Office Action Summary

09/894,121

KITAHARA, TSUYOSHI

- I. Claims 14-24, drawn to a process of making a piezoelectric vibrator unit by forming slits to elongate an area, classified in class 29, subclass 25.35.
- II. Claims 25-29, drawn to a process of making a piezoelectric vibrator unit by forming slits to produce divided conductor regions, classified in class 29, subclass 417.

Attachment A

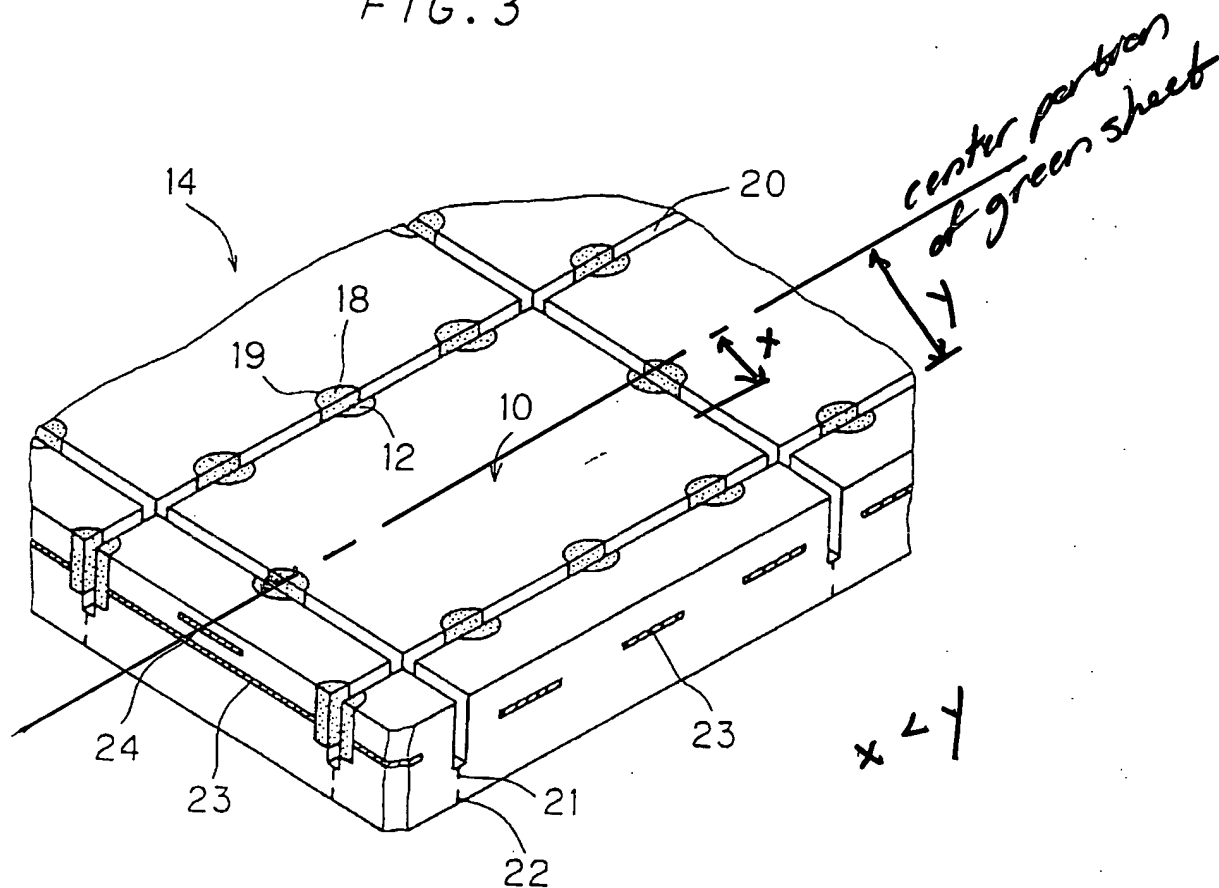
Regarding Claims 21-22, the examiner has provided Attachment A of Kubota's Figure 2, which shows one set of through holes slightly offset from the other set of through holes such that the through holes of alternate layers, or all of the layers, are positioned in one line.

Regarding Claims 23-24, the through holes of Kubota appear to have a greater width than the thickness of the respective green sheet upon reviewing Figure 2. However, if applicants' do not believe that the width of the through holes is larger than the thickness of the respective green sheet, then it would have been an obvious matter of design choice to choose any desired width of the through holes since the applicant has not disclosed that the claimed relative width of the through holes solve any stated problem or is for any particular purpose and it appears that the invention would perform equally well with the width of the through holes taught by Kubota.

Attachment B

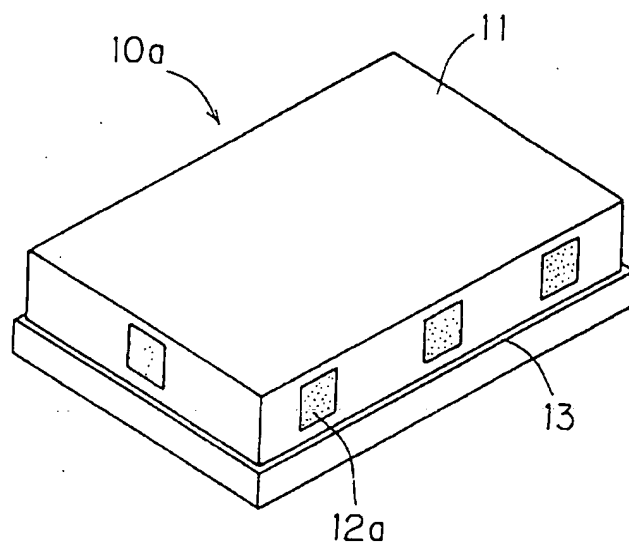
The examiner most respectfully traverses and for further clarification, has provided Attachment B illustrating what is being read as a "strip-shaped non-conductive region" in Kubota's Figure 3. The highlighted region (in yellow) shows a strip-shaped non-conductive region formed on the green sheet that is nearer to a center portion of the green sheet (red dashed line drawn by the examiner) than the through holes formed to the right of the highlighted region.

It is noted that the phrases of "strip-shaped non-conductive region" in "an area" are very broad and relative phrases to describe the relationship of the non-conductive region with the through holes. So broad in fact, that the highlighted region selected by the examiner can satisfy the limitations of the relationship of the "strip-shaped non-conductive region" with the through holes and it appears that further limitations are needed to avoid Kubota.
